**STAFF REVIEW AND RECOMMENDATIONS
PUBLIC HEARING
MAY 25, 2022**

STAFF REVIEW AND RECOMMENDATIONS
PUBLIC HEARING
May 25, 2022

ABBREVIATED PLAT: NOLAN ADD #1 LOTS 2A, 3A & 5A

REVIEWED BY: MATTHEW GODDARD CASE #: 2022-061

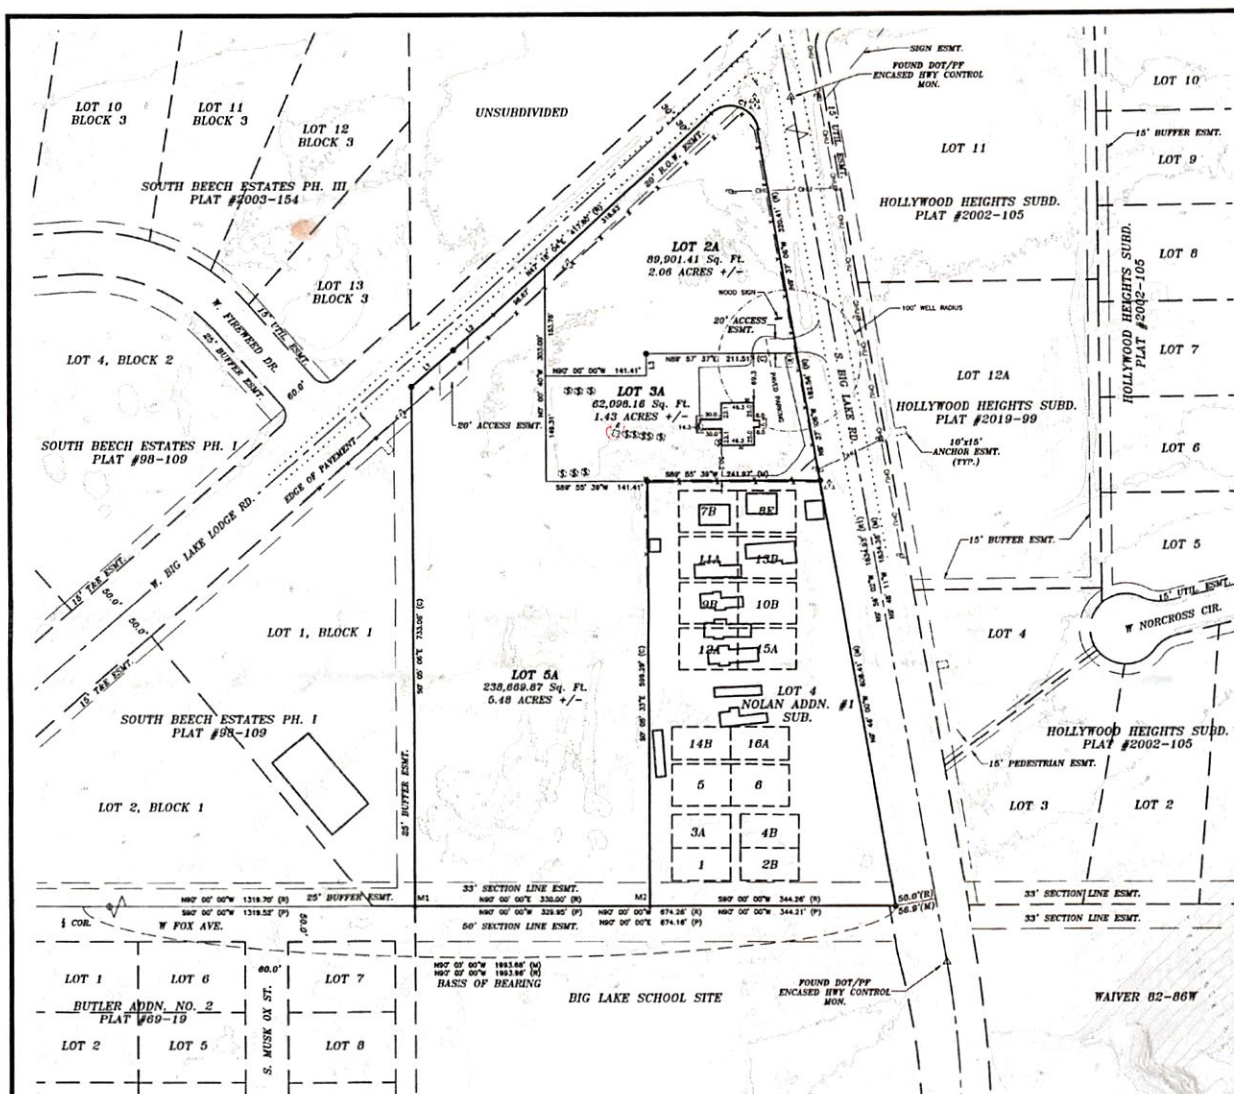
MEA has an easement that was not recorded or listed on the plat. I recently recorded it and attached it here for your records. Thank you for the opportunity to comment.
